**STAFF REPORT: JUNE 11, 2025 MEETING**

**APPLICATION NUMBER: HDC2025-00203**

**ADDRESS: 4069 STURTEVANT**

**SCOPE: REPLACE ASPHALT ROOF WITH METAL ROOF, INSTALL GUTTERS/DOWNSPOUTS, REPLACE REAR PORCH ENCLOSURE, (WORK COMPLETED WITHOUT APPROVAL), INSTALL RAILING AT FRONT PORCH**

*Applicant cut-sheet and drawing of proposed railings for front porch stairs.*

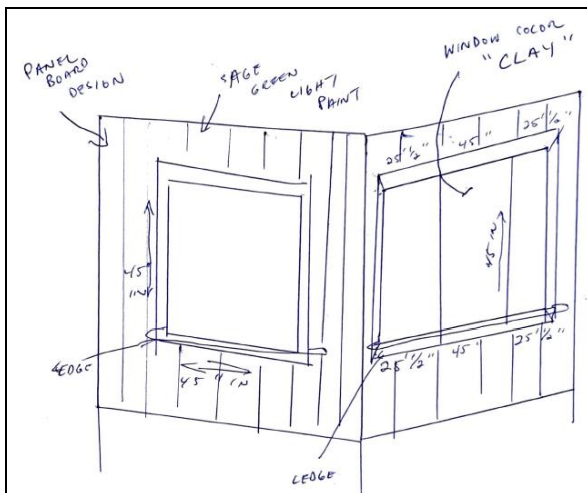
- Regarding the proposed front porch railing, it appears a black metal railing was in place at time of designation (as was the chain-link driveway gate). The main issue staff has with the proposed railing is the stated 45" height. A 36" railing would be appropriate and proportional for the stairs. The applicant should confirm in writing that no railing will be applied to the low masonry walls.

- The top railing of the porch railing be a maximum 36" from the step surface.
- The gutters, downspouts and collector boxes will be painted dark brown, similar to the asphalt shingle roof and brick veneer on the house walls; or, the Sherwin Williams Sage Green Light, which will be used on the house's trim.

*Left: Copper components newly installed*

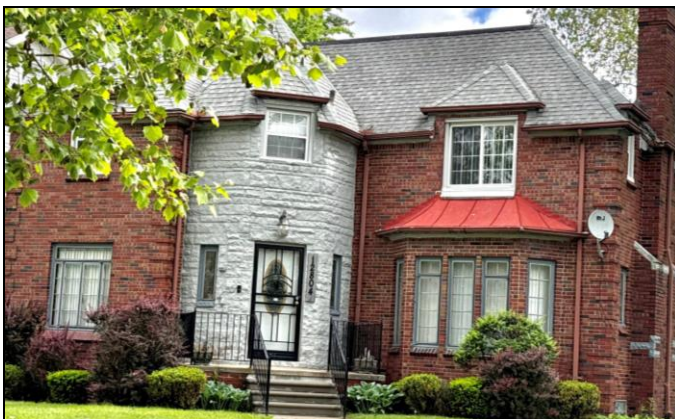
- Staff appreciates the selection of finely ridged downspouts, and detailed and appropriately-scaled collector boxes. The challenge with the installed components is the “coppertone” color. When real copper components are installed, they are brilliant in color and have an exceptionally shiny finish, similar to the products used at this property. However, the bright shiny finish is temporary (for a few years); the long-term finish is achieved through oxidization – when copper forms a coating that turns dark gray and eventually develops the distinguishing and highly identifiable patina of a deep rich green color. Painted/coated metal (i.e., aluminum/steel) components conversely will never change color and will retain the bright and shiny “copper” color. This unchanging contrast of color and finish is not compatible for this English Revival dwelling, where the overall color palette is generally muted and with matte finishes.

- The “coppertone” color of the installed gutters, downspouts and collector boxes is bright and shiny; and, unlike real copper, will retain its bright, shiny finish for the duration of their installation. This unchanging contrast of color and finish with the dark brick exterior walls is not compatible for this English Revival dwelling, where the overall color palette for this architectural style is muted and with matte finishes.
